INDEPENDENT SEISMIC DESIGN VERIFICATION  
TURBINE DRIVEN SECTION  
EMERGENCY FEEDWATER SYSTEM  
V.C. SUMMER NUCLEAR STATION  
DRAFT FINAL REPORT: SEPTEMBER 30, 1982

SOUTH CAROLINA  
ELECTRIC & GAS COMPANY

September 30, 1982

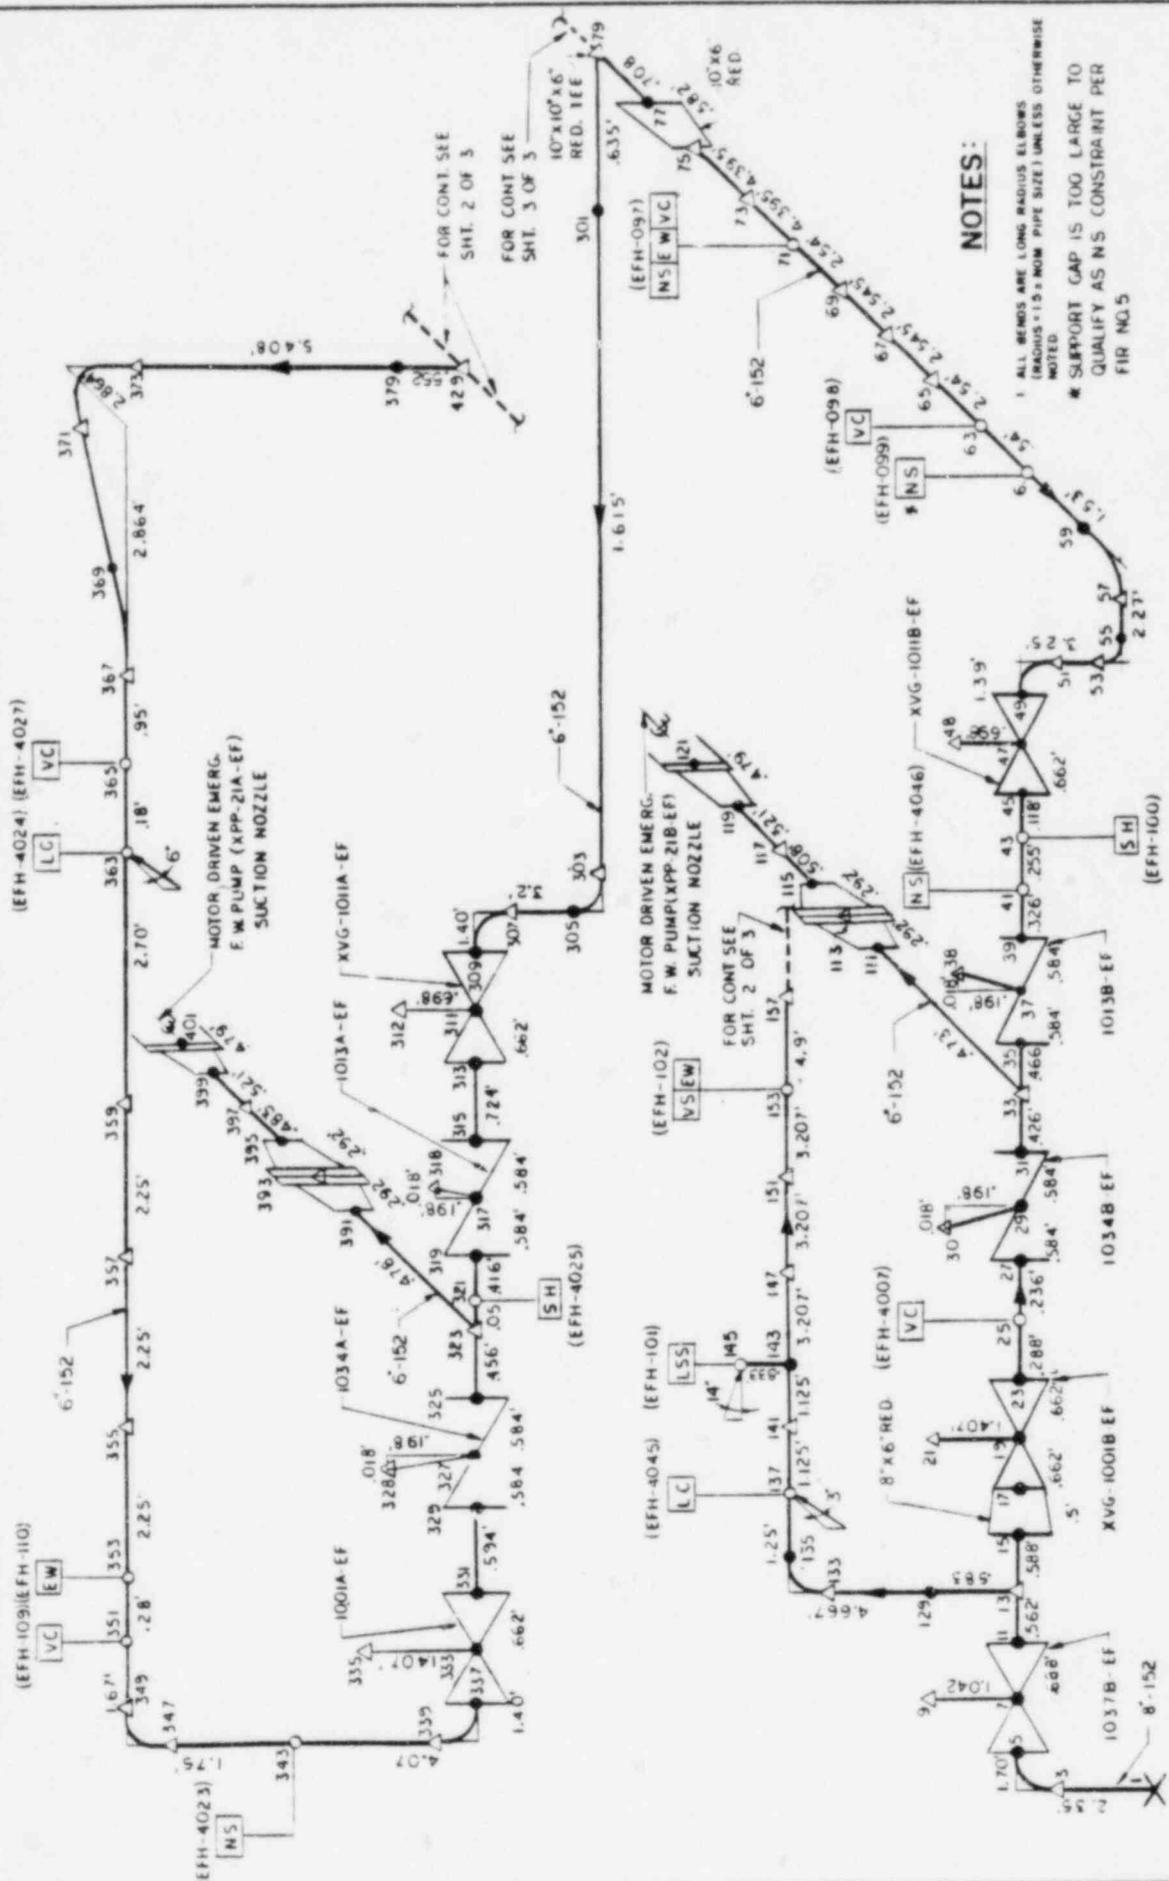
EFH-099 (Stress Package 101) was originally designed as a North-South restraint. During field walkdown the clearance was found to exceed the criteria, therefore, this support was assumed ineffective in the stress analysis. The result of the analysis verified that this assumption was correct. The maximum thermal displacement is 0.019 inch at this point. The total displacement including the effects of deadweight, thermal and seismic will amount to 0.030 inch, much less than the existing clearance.

**NOTES:**  
 1 ALL BENDS ARE LONG RADIUS ELBOWS (RADIUS = 1.5 x NOM. PIPE SIZE) UNLESS OTHERWISE NOTED  
 \* SUPPORT GAP IS TOO LARGE TO QUALIFY AS NS CONSTRAINT PER FIR NO.5

FIGURE 4-3  
WORK SKETCH FOR PACKAGE 103

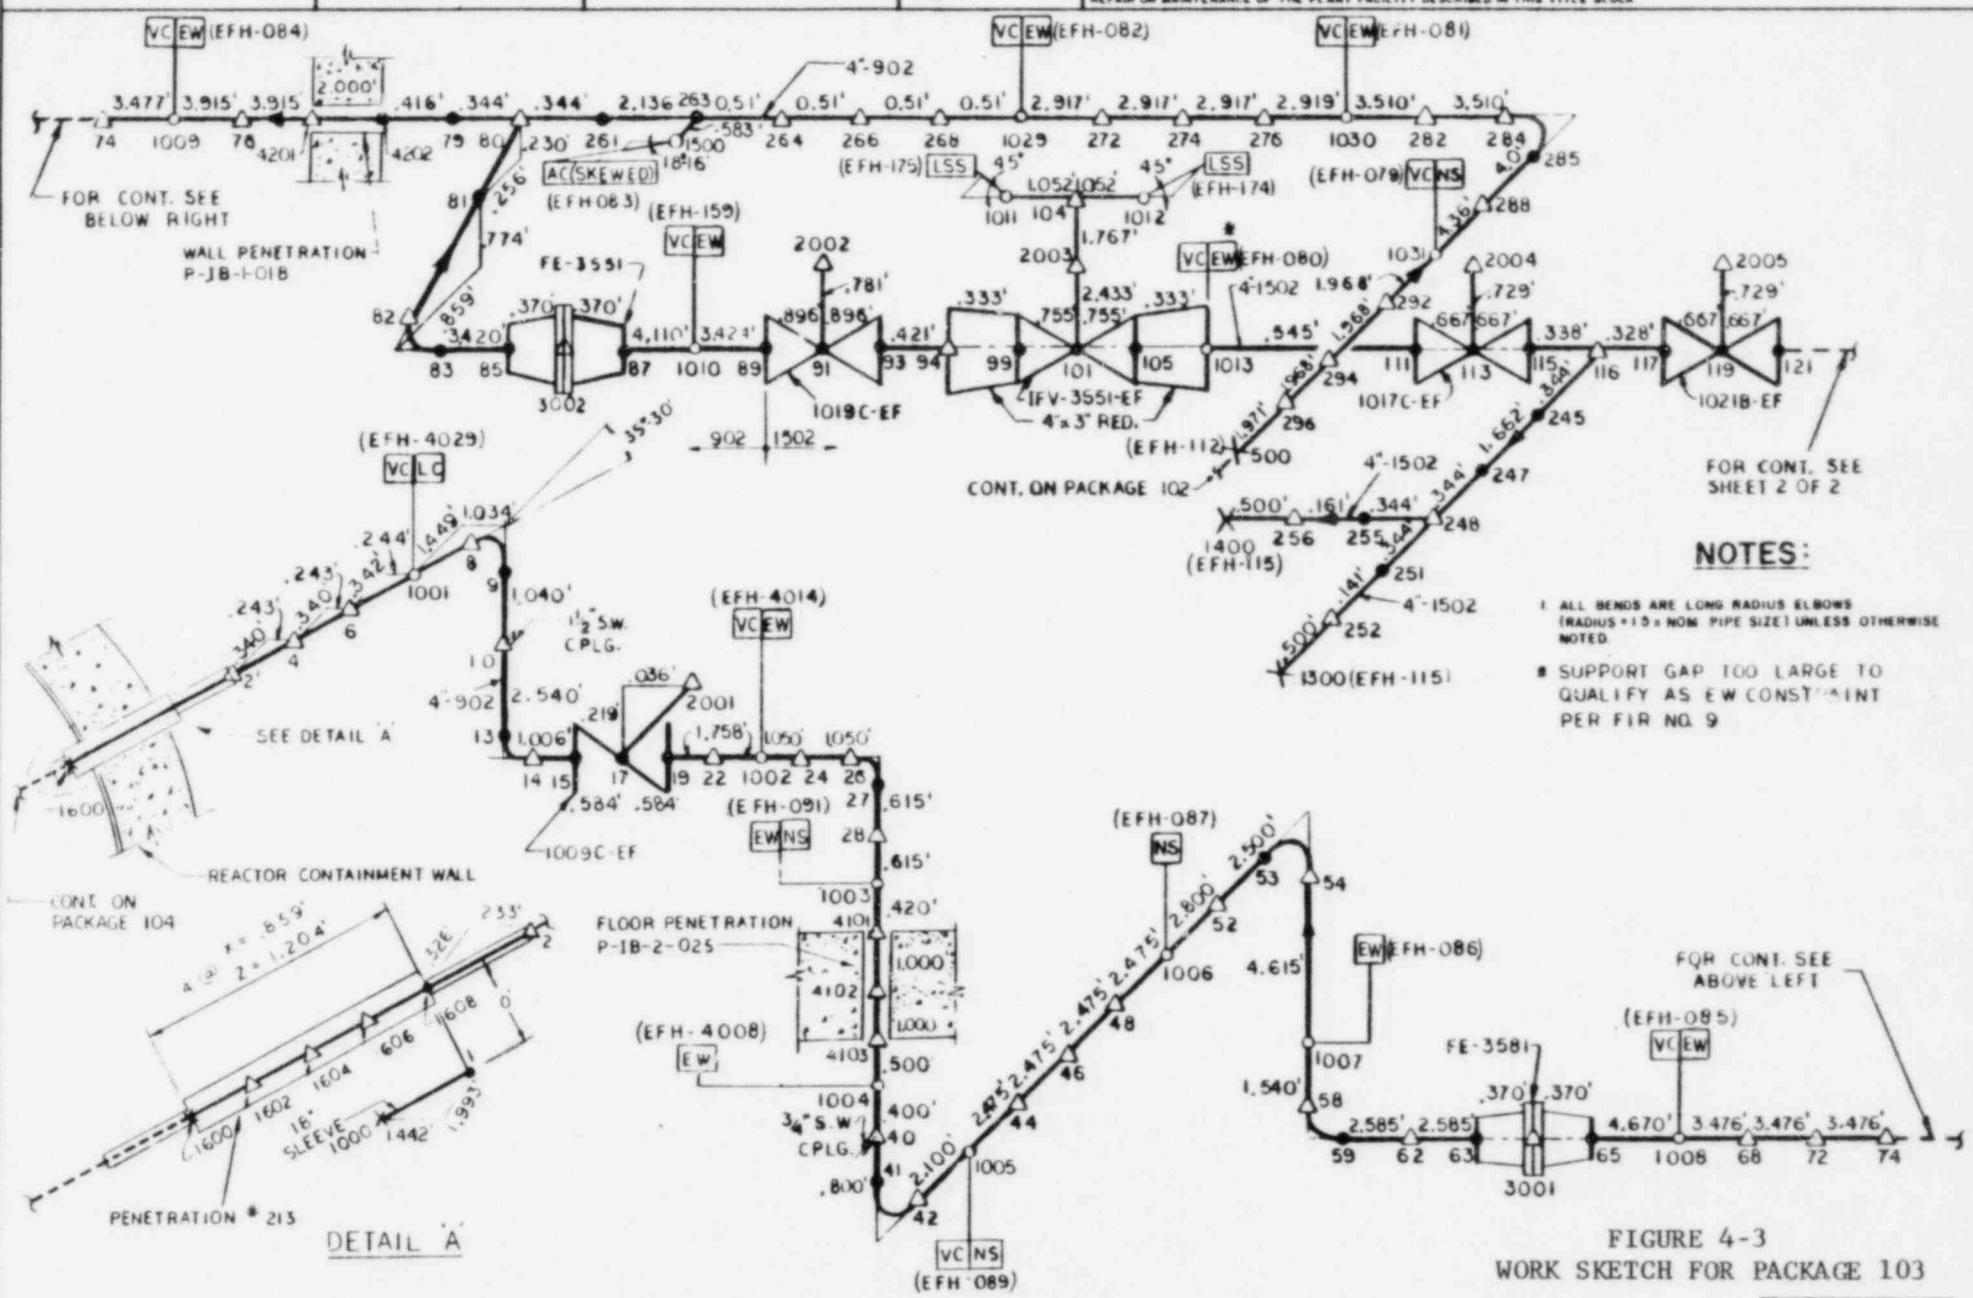
EFH-080 (Stress Package 103) was originally designed as a vertical and East-West restraint. Since the horizontal gap exceeded the criteria, the East-West restraint was considered ineffective in the analysis. The result of the analysis indicates that thermal movement is 0.019 inch, and total displacement including the effects of thermal, seismic and deadweight is 0.032 inch, much less than the existing clearance. Therefore, the assumption is verified to be correct.

- NOTES:**
- 1. ALL BENDS ARE LONG RADIUS ELBOWS (RADIUS = 10 x NOM. PIPE SIZE) UNLESS OTHERWISE NOTED.
  - 2. SUPPORT GAP TOO LARGE TO QUALIFY AS EW CONSTRAINT PER FIR NO. 9
